Access Compliance Report Public Rights-of-Way (Curb Ramps)

Main Street: N/A Cross Street: MERCANTILE_WAY Location: NW

ADA ID: RPRK211102113724 Ramp Type: Type 4 - Parallel Initial Pass/Fail: Fail Overall Compliance: No Severity Score: 30

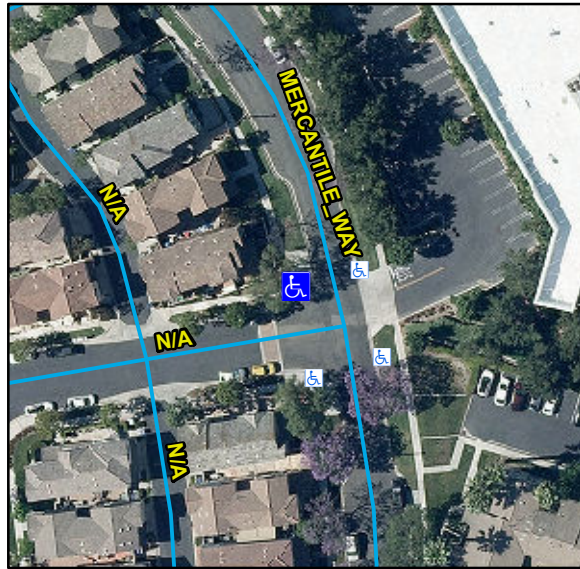
Compliance	Description	Data	Compliance	Description	Data
N/A	Ramp Length LT (in)	113	N/A	Ramp Length RT (in)	108
Yes	Ramp Width LT (in)	90	Yes	Ramp Width RT (in)	90
Yes	Ramp Run Slope LT (%)	0.8	Yes	Ramp Run Slope RT (%)	8.3
Yes	Ramp Cross Slope LT (%)	1.6	No	Ramp Cross Slope RT (%)	8
N/A	Landing Present	N/A	N/A	DWS Provided	N/A
N/A	Landing Length (in)	N/A	N/A	DWS Contrast	N/A
N/A	Landing Width (in)	N/A	N/A	DWS Length (in)	N/A
N/A	Landing Run Slope (%)	N/A	N/A	DWS Full Width	N/A
N/A	Landing Cross Slope (%)	N/A		DWS Offset Type	N/A
N/A	Landing Movement Obstructed?	N/A	N/A	DWS Offset Left (in)	N/A
	Landing Movement Type	N/A	N/A	DWS Offset Right (in)	N/A
N/A	Landing Shared	N/A			
N/A	Clear Space	Yes			
N/A	Clear Space To Crosswalk (in)	N/A			
N/A	Marked Crosswalk 1	No	N/A	Marked Crosswalk 2	No
	Crossing 1 Direction	S		Crossing 2 Direction	E
N/A	Marked Crosswalk 1 Width (in)	N/A		Marked Crosswalk 2 Width (in)	N/A

Remove & Replace Curb Ramp With Two New Directional Ramps or Equivalent.

R204.3, R304.5.3, STD 1115
